March 22, 2007

SUBJECT: DEMONSTRATION / DELIVERY HOLD: Safety Recall 07S50:
Certain 2008 F-250/350/450/550 Vehicles Equipped with a 6.4L Diesel Engine
Battery Cable Inspection and Adjustment

CERTAIN 2008 F-250/350/450/550 VEHICLES EQUIPPED WITH A 6.4L DIESEL ENGINE – BATTERY CABLE INSPECTION AND ADJUSTMENT

FIGURE 1

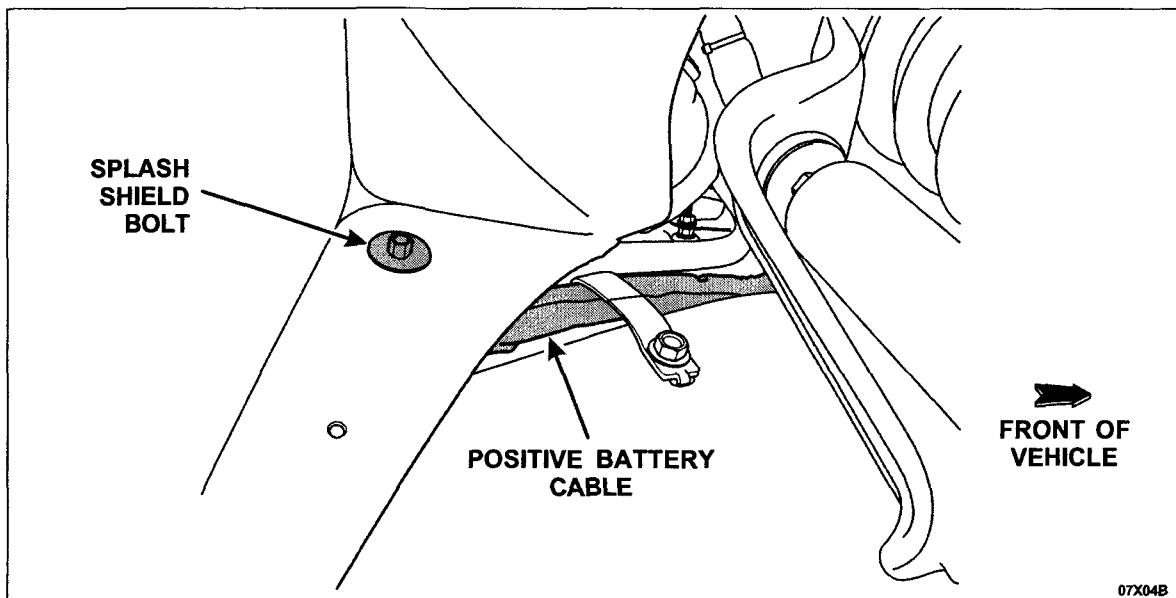
1. Place the vehicle on hoist.
2. Verify that there is at least 15 mm (5/8 in) of clearance between the positive battery cable and the splash shield bolt by placing your hand between them. See Figure 1.

FIGURE 2

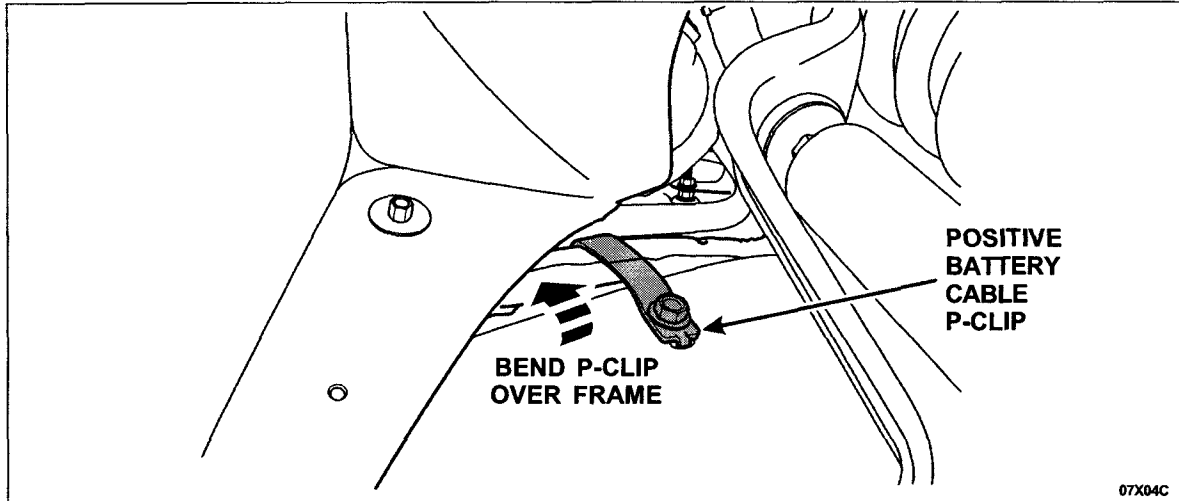
3. If you are unable to fit your hand between the splash shield bolt and the positive battery cable (at least 15 mm [5/8 in]), bend the P-clip over the frame and recheck for clearance. See Figure 2.

FIGURE 3

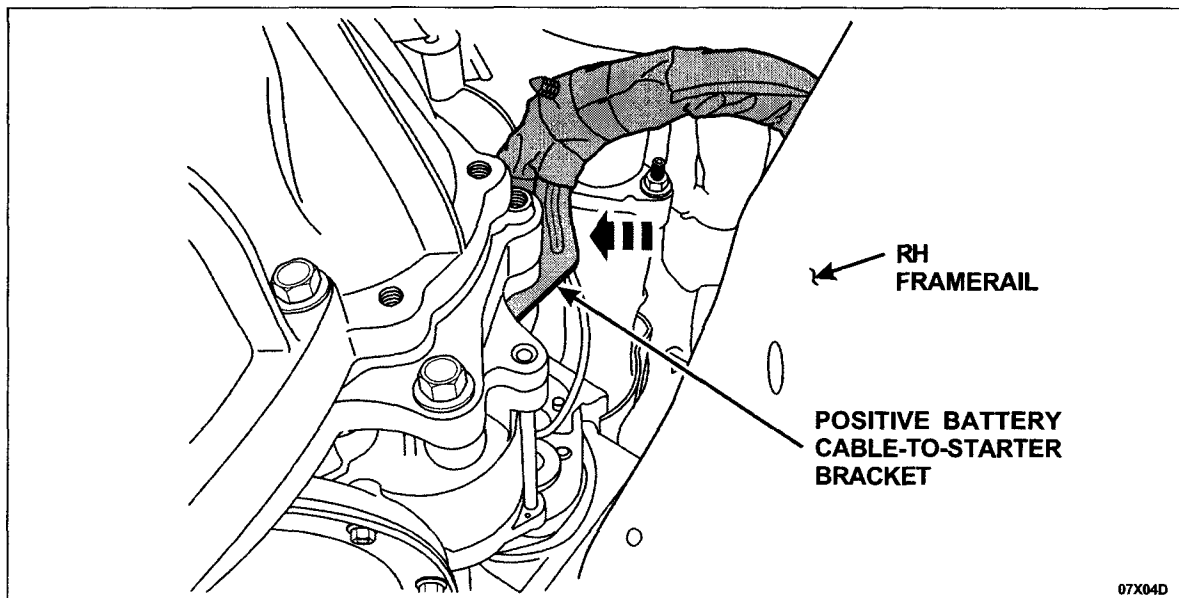
4. If still unable to fit your hand between the splash shield bolt and the positive battery cable (at least 15 mm [5/8 in] clearance), then pull the cable towards the engine to bend the positive battery cable-to-starter bracket to create the necessary clearance (at least 15 mm [5/8 in]). Then verify the clearance between the splash shield bolt and the positive battery cable. See Figure 3.
